EDWIN I. HATCH NUCLEAR PLANT  
UNIT 1

CONTAINMENT LEAK RATE TEST PROGRAM

## I. INTRODUCTION

## II. PROPOSED PLANT MODIFICATIONS

**PENETRATION Y25: ADD A BLOCKING VALVE AND TEST CONNECTION BETWEEN VALVE T48-F118A AND THE PENETRATION**  
 Figure 1 (Reference H-16000)

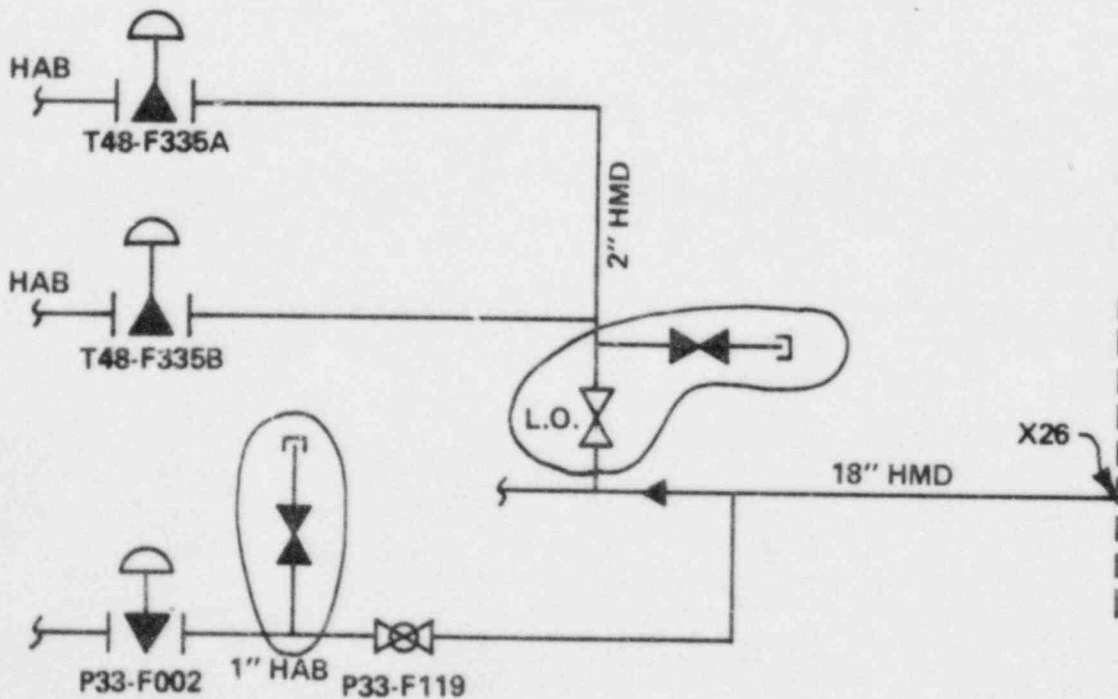
Penetration X25 - Vent Purge Supply:

Valve T48-F118A is a globe valve pressurized in the reverse direction during leakage testing. The valve cannot be conservatively tested in the reverse direction. A blocking valve and test connection installed as shown on Figure 1 will allow testing of valve T48-F118A in the proper direction. The modification shown in Figure 1 will also allow pressurizing of valves T48-F114 and T48-F322 in the correct direction. This arrangement is beneficial, although the two control valves may be conservatively tested as installed. This modification requires one 2" and one 3/4" ASME Section III Class 2 valves.

**PENETRATION X26: ADD TEST CONNECTIONS AND A BLOCKING VALVE**  
 Figure 2 (Reference H-16024 and H-16276)

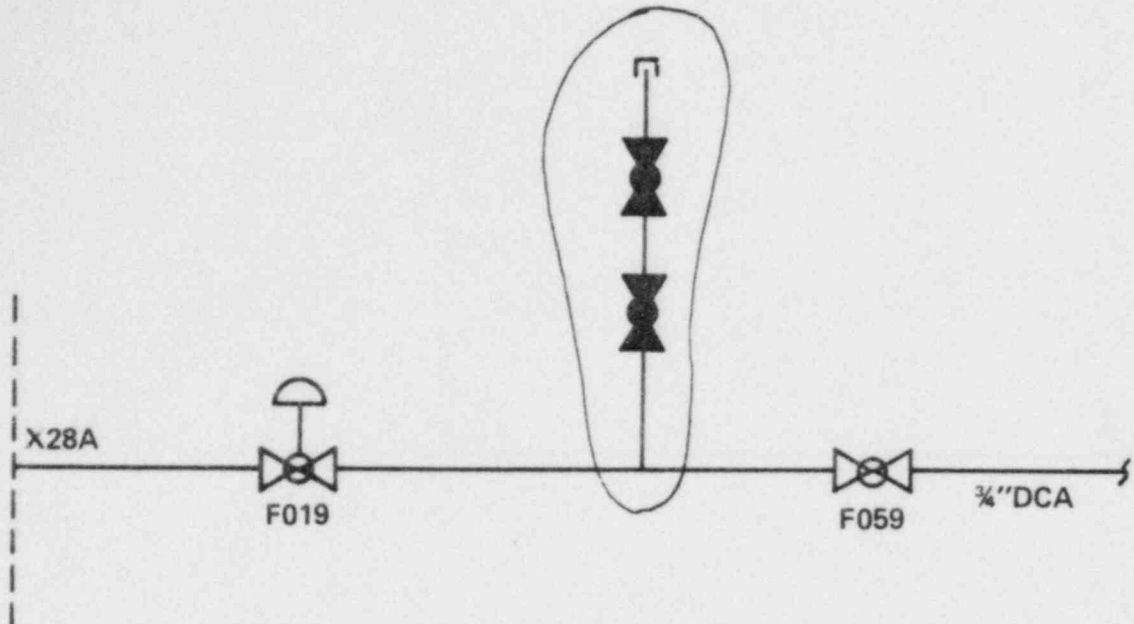
Penetration X26 - Vent Purge Return/H<sub>2</sub> & O<sub>2</sub> Analyzer:

This penetration has three control valves not conservatively tested in the reverse direction: T48-F335A and B, and P33-F002. As shown on Figure 2, T48-F335A and B can be tested in the correct direction by installing one blocking valve and a single valve test connection in the common line. P33-F002 has a blocking valve upstream and needs only the addition of a single valve test connection. Two 3/4" and one 2" ASME Section III Class 2 valves are required for these modifications.

Figure 3 (Reference H-16066)

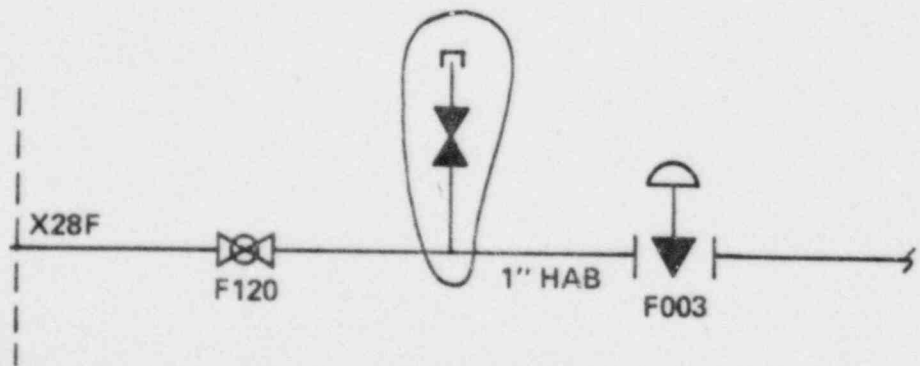
Penetration X28A - Recirculation Sample

Valve B31-F019 is a globe valve that cannot be conservatively tested in the reverse direction. As shown on Figure 3, a blocking valve is presently installed but a test connection is required between B31-F019 and the blocking valve. Two 3/4" ASME Section III Class 1 valves are required for this modification.

PENETRATION X28A: ADD A TEST CONNECTION

Figure 4 (Reference H-16276)

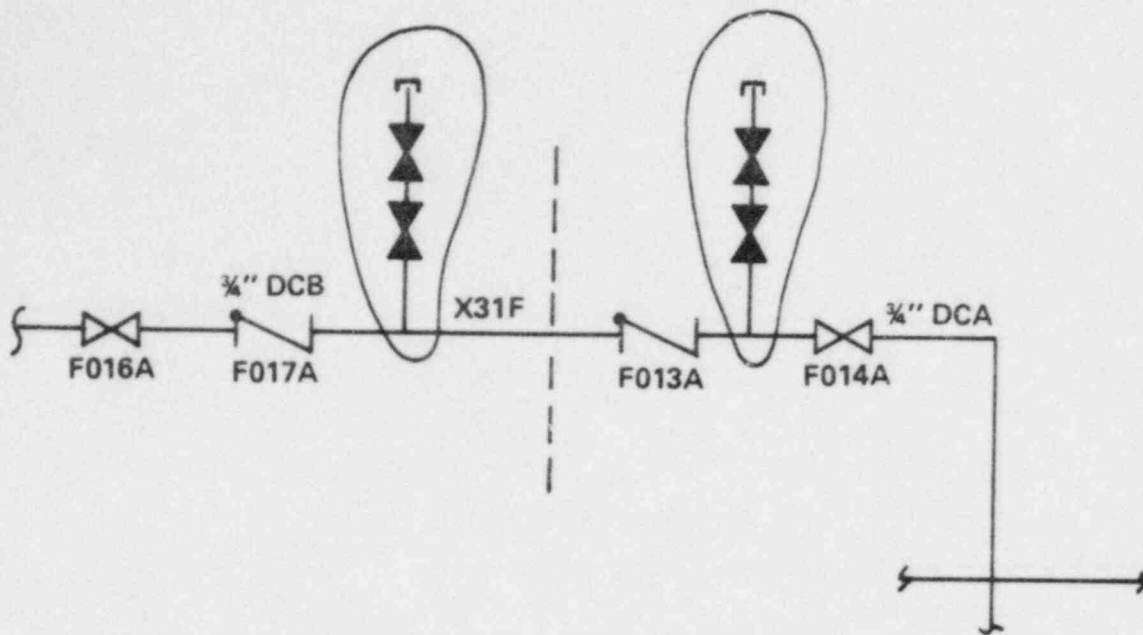
Penetration X28F - H<sub>2</sub> & O<sub>2</sub> Analyzer:

P33-F003 is a control valve non-conservatively pressurized in the reverse direction. As shown on Figure 4, a blocking valve is presently installed, but a test connection is required between P33-F003 and the blocking valve. One 3/4" ASME Section III Class 2 valve is required for this modification.

PENETRATION X28F: ADD A TEST CONNECTION

Figure 5 (Reference H-16066)

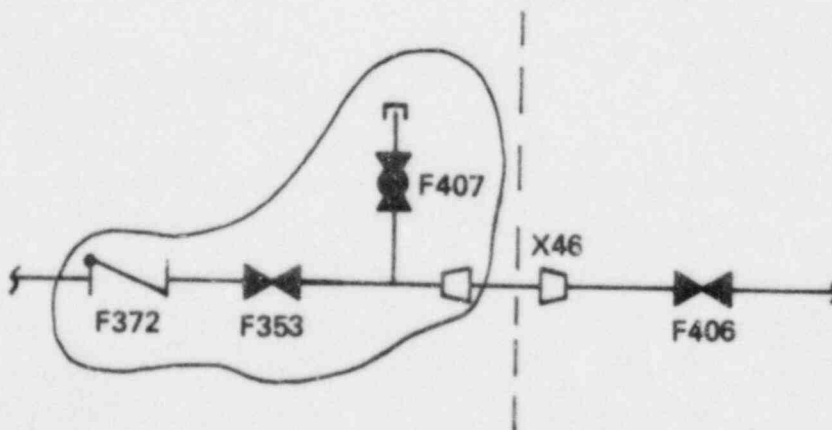
Penetration X31F - Recirculation Pump Seal Water:

The present system design does not provide testing capabilities for check valves B31-F013A or B31-F017A. Test connections are required as shown in Figure 5. This modification requires four 3/4" ASME Section III Class 2 valves.

Penetration X59A - Recirculation Pump Seal Water:

This penetration design is identical to X31F (see Figure 5). Testing capabilities are not provided for check valves B31-F013B or B31-F017A. Test connections are required as shown in Figure 5. This modification requires four 3/4" ASME Section III Class 2 valves.

**PENETRATION X31F: ADD TEST CONNECTIONS BETWEEN VALVES B31-F017A, B31-F013A, AND B31-F014A. PENETRATION X59A IS IDENTICAL.**

Figure 6 (Reference H-16015)

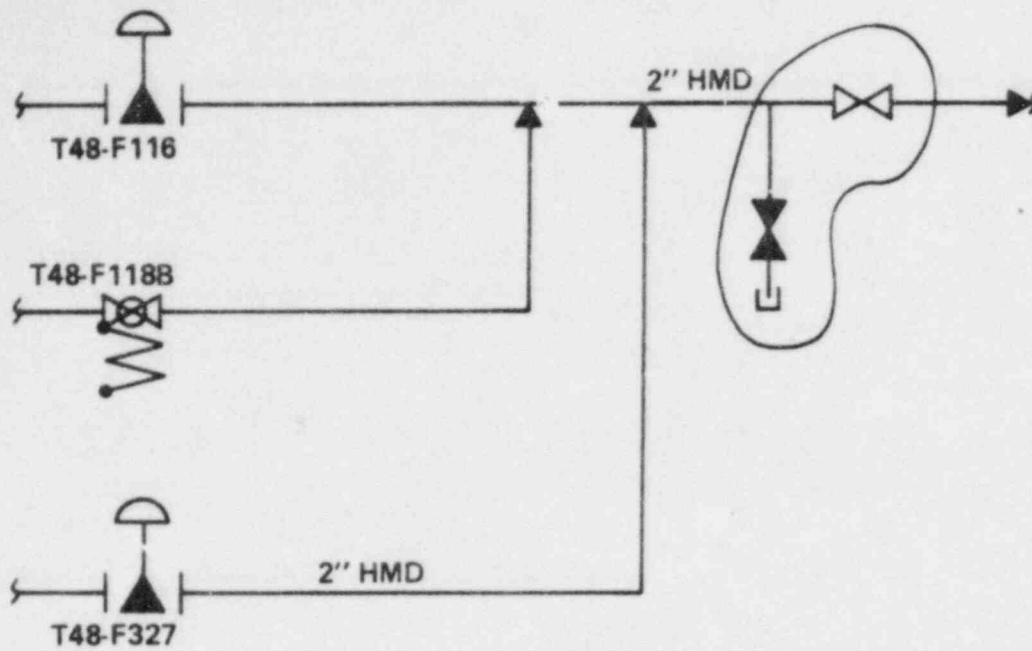
Penetration X46 - Demineralized Water:

The present system design has check valve P21-F372 installed between locked closed manual isolation valves P21-F406 and P21-F353. This arrangement results in the utilization of check valve P21-F372 as an isolation valve. The relative position of valves P21-F372 and P21-F353 should be interchanged and the test connection should be between P21-F353 and P21-F406 as shown in Figure 6. P21-F406 should be tested with pressure in the correct direction by pressurizing through a drywell hose connection. No additional valves are required for this modification.

**PENETRATION X46: EXCHANGE POSITION OF P21-F353 AND P21-F372 ENSURE TEST CONNECTION IS BETWEEN P21-F353 AND P21-F406.**

Figure 7 (Reference H-16000)

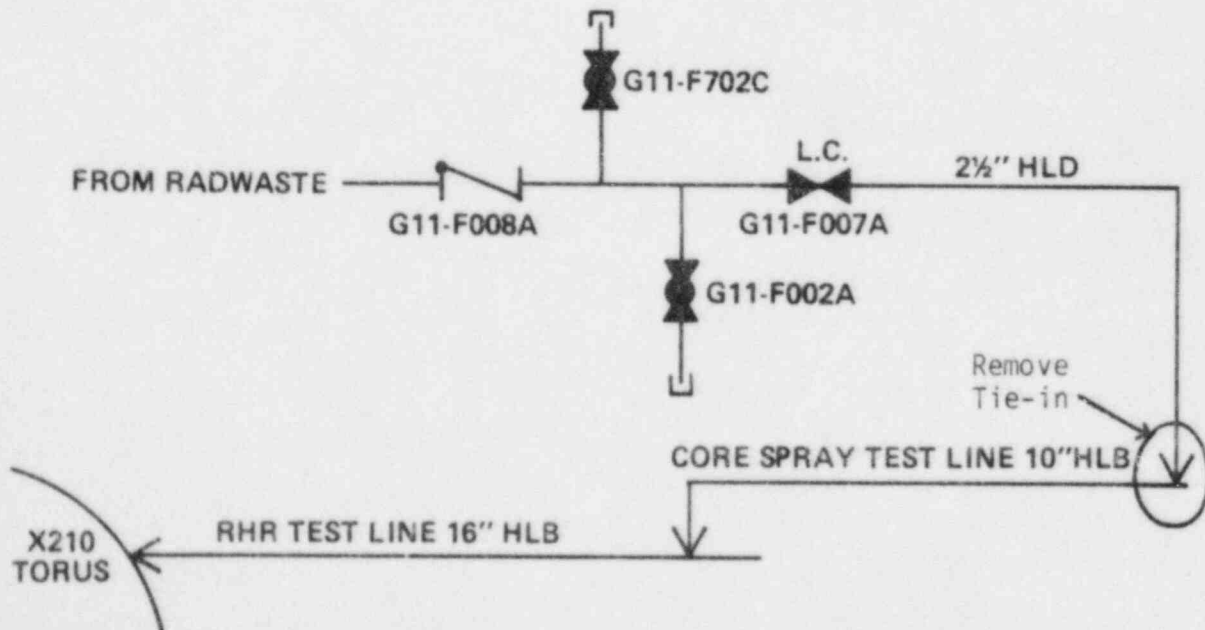
Penetration X205 - Containment Purge and Inerting:

Globe isolation valve T48-F118B cannot be tested conservatively in the reverse direction. The modification shown in Figure 7 is similar to the one discussed for penetration X25.

**PENETRATION X205: INSTALL A BLOCKING VALVE AND TEST CONNECTION BETWEEN T48-118B AND THE PENETRATION**

Figure 9 (Reference H-16276)

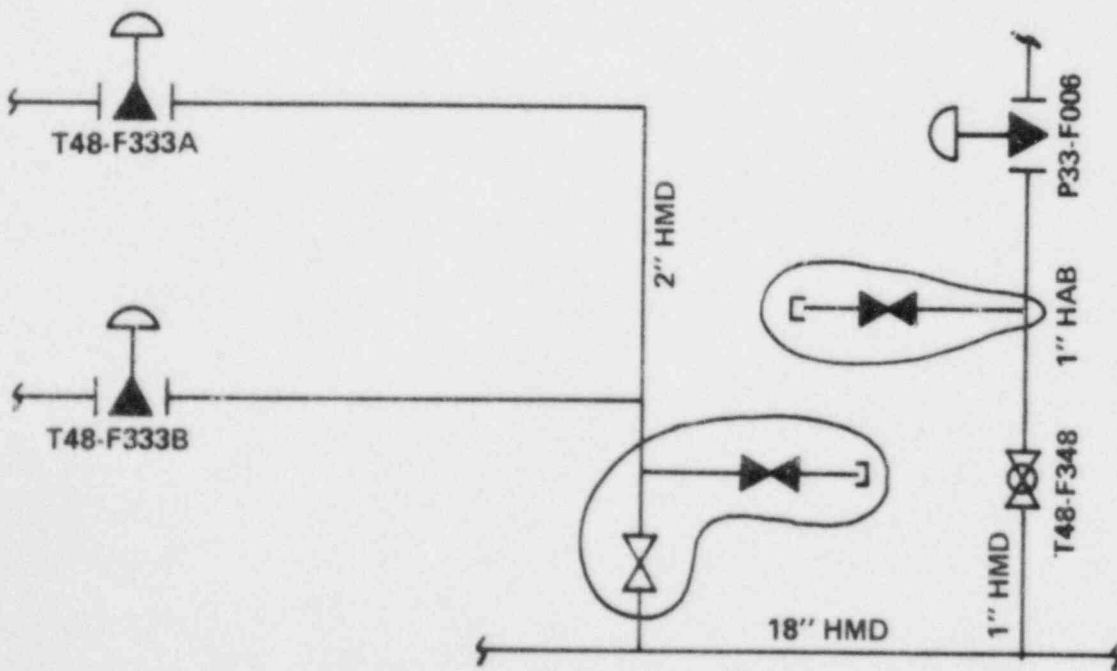
Penetration X217 - H<sub>2</sub> & O<sub>2</sub> Analyzer:

P33-F007 cannot be leakage tested in the correct direction and a reverse pressure test is not conservative. A blocking valve is part of the present system design. Therefore, an installed test connection will provide the required leakage testing capability for this valve (see Figure 9). This modification requires one 3/4" ASME Section III Class 2 valve.

**PENETRATION X217: ADD A TEST CONNECTION BETWEEN P33-F007 AND P33-F126**
